Rezoning Transportation Analysis

Petition Number: 2025-031

General Location Identifier: 04711202, 04711206

Date	Description
04-23-25	First Review (TM)
05-21-25	Second Review (TM)
10-23-25	Third Review (TM)

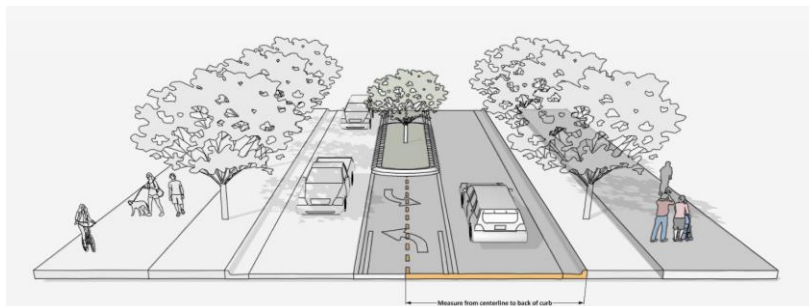
- a. ~~IBM Drive:~~ Location of future curb and gutter is to be 19 feet from roadway centerline to back of curb. This location does not include additional turn lanes.

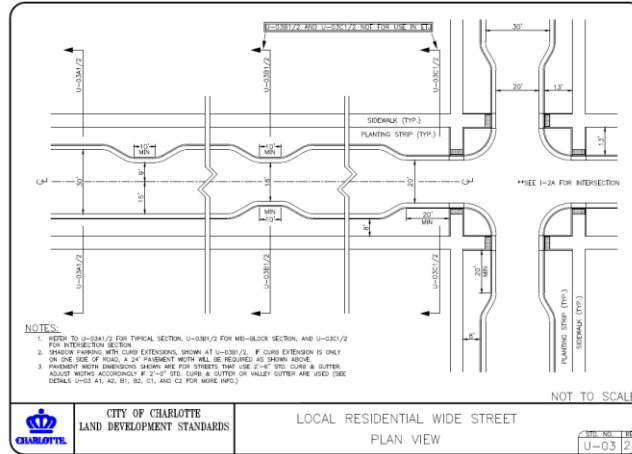
- b. ~~Neal Road:~~ Location of future curb and gutter is to be 19 feet from roadway centerline to back of curb. This location does not include additional turn lanes.

- c. **Catalyst Drive:** Location of future curb and gutter is to follow CLDSM U-03.

Outstanding Comment 4.23.2025: Label and dimension the curb and gutter from the centerline for each road on the site plan.
